Engineering Bulletin

Direct Fired LP-Gas Vaporizer, 40/40H & 80/40H

Bulletin Number: DF 10/03

Main gas lock-in with Robertshaw thermostatic gas valves

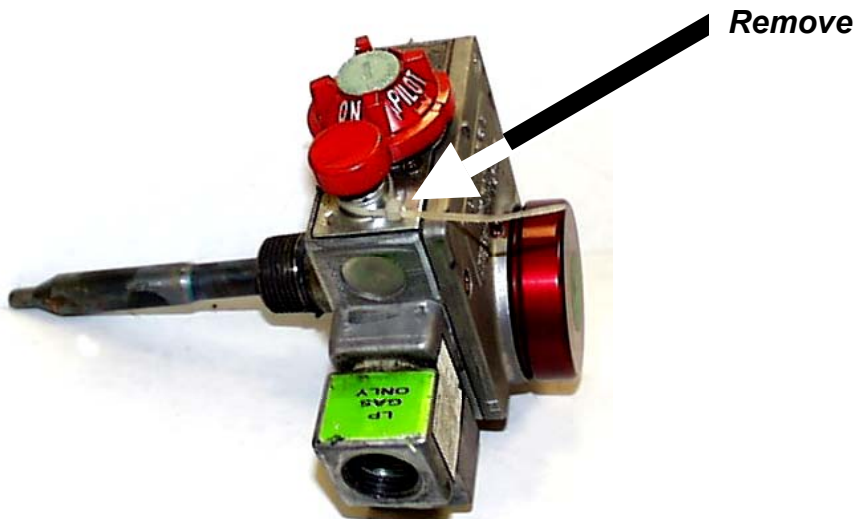
Problem: Pilot ignites ok but will not stay engaged once the override button is released.

Resolution: Remove plastic zip tie connected to tag that is located at base of safety interlock override button. This zip tie will prevent the override button from being depressed far enough to allow proper lock-in.

This tag has been relocated on units manufactured after September 2003.
